COMMENTS RESPECTING THE DRAWING

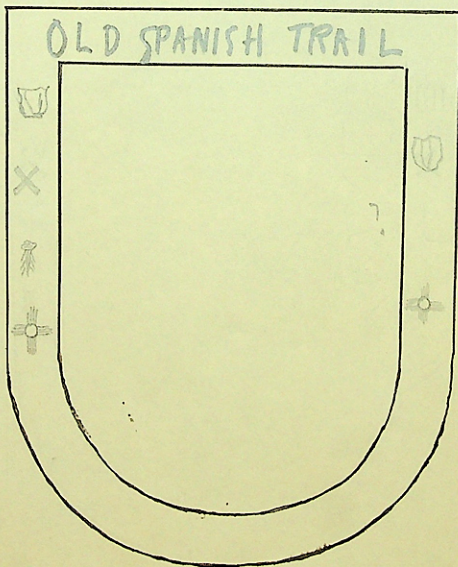
Shell--should be more distinctly a shell. See photostats.

Cross--all right as now. Photostats the guide.

Sun Cross--not according to copy. New copy herewith, also the following comment as guide to the drawing. "There are many sun symbols but this appealed because it is 'different' and expressive. The lines of the Zia sun symbol were drawn free hand, they lacked stiffness of design as now used, yet they were by no means crude, just abit out of straight line, the circle very well drawn." This cross should be the free hand type.

Ermine--On photostats B and C, small design  , the ermine. (symbolizes the purity of their knightly purposes.)

*Corrections have been made according to above APR*
